UNITED STATES PATENT AND TRADEMARK OFFICE

APPLICATION NO.	FILING DATE	FIRST NAMED INVENTOR	ATTORNEY DOCKET NO.	CONFIRMATION NO.
10/500,162	06/25/2004	Magalic Genct	0501-1097	7425

Office Action Summary	Application No.	Applicant(s)	
	10/500,162	GENET ET AL.	
	Examiner	Art Unit	
	John F. Ramirez	3737

DETAILED ACTION

Fig. 2

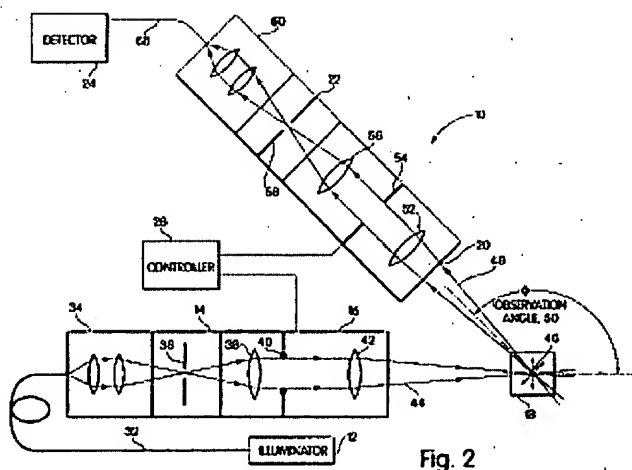
The Modell et al. patent teaches a system with an optical head being equipped with optical means adapted for converging the excitation signal coming out of said bundle into a subsurface analysis zone, and the same optical fiber or fibers of said bundle having served for carrying the excitation signal being used for detecting the signal emitted by said subsurface analysis zone (see figure 2, elements 36 and 38, figures 3A-3B, col. 12, line 30-col.14, line 36).

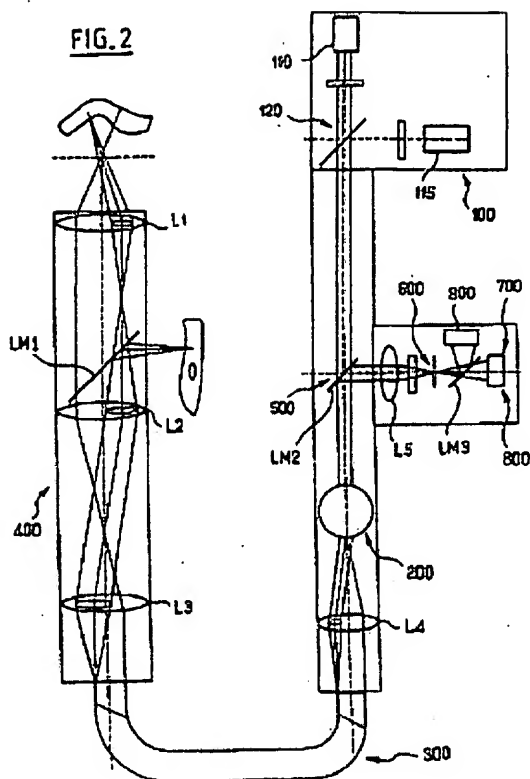
The Le Gargasson et al. patent teaches a system for spectroscopy analysis characterized in that comprises a glass plate placed at the output of the optical fiber bundle and shared with the optical head (unit 400, L1), said plate being sufficiently thick to reject the parasitic parallel reflections at the output said fiber bundle (col. 7, lines 12-29), characterized in that the means for injecting into the optical fiber bundle has a wave front quality and a spatial distribution of the focal spot intensity adapted to the useful diameter of the fiber bundle (col. 7, lines 12-29), characterized in that the excitation source emits at a wavelength adapted to excite chosen endogenous fluorophores present biological tissues of the observed site (col. 8, lines 17-30), characterized in that the means for separating the wavelengths is a dichroic plate (see figure 2, element 120), characterized in that the means for spectroscopic analysis comprise a spectrograph and a means of coupling to the slit of the spectrograph (col. 14, lines 66-67, col. 7, lines 18-21), characterized by means for rejecting placed upstream of the coupling means and adapted for eliminating the backscattered excitation wavelength (see figure 2, col. 4, lines 19-31), characterized by a lens placed upstream of the means for rejecting adapted for improving the signal-to- noise ratio (col. 4, lines 38-46),
